picoScan150 - Firmware release information V1.x.x

Document published 23 Aug 2024

2D Object Detection

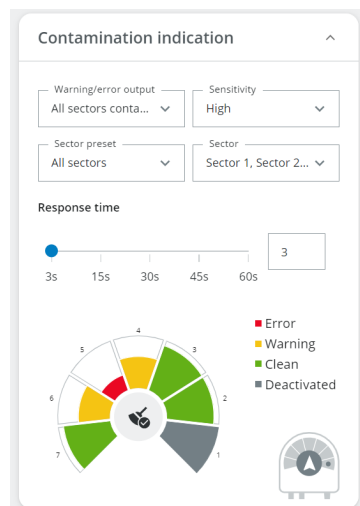
The new “Field Evaluation” application allows the definition of up to 48 individual fields (evaluations).

- Fields can be merged into groups
- Groups can be activated by telegram or input signal.
- The field status and application status can be monitored by telegram and output signal.

- Parametrization options:
 - The maximum blanking size and detection time can be individually configured
 - Distance-dependent: Measuring points inside a field are combined depending on distance.

- Manipulation prevention: Object detection is triggered as soon as monitoring from the device to the field boundary is not sufficiently possible.
 - Ignore missing echo: A missing echo is treated as if it were a measuring point in the field.

- Evaluation modes:
 - Blanking: Field evaluation reacts to all measurement points
 - Reflector: Field evaluation reacts only to measurement points marked as reflector

- Detection history can be activated with up to 200 entries. The oldest entry will be deleted in case of a new detection.

License Manager Support

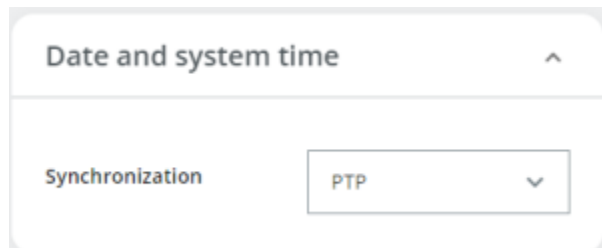
The License Manager is integrated and can be accessed via <http://192.168.0.1/#/license>.

IMU (inertial measurement unit support)

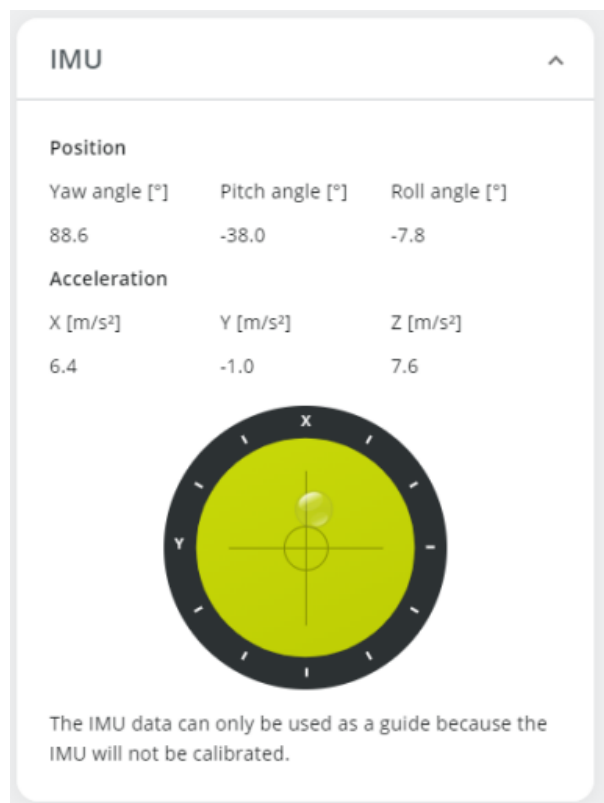
IMU data is enabled with this release. IMU data is available in compact format. The following info is shown in the UI.

IMU type: BOSCH BHI160B
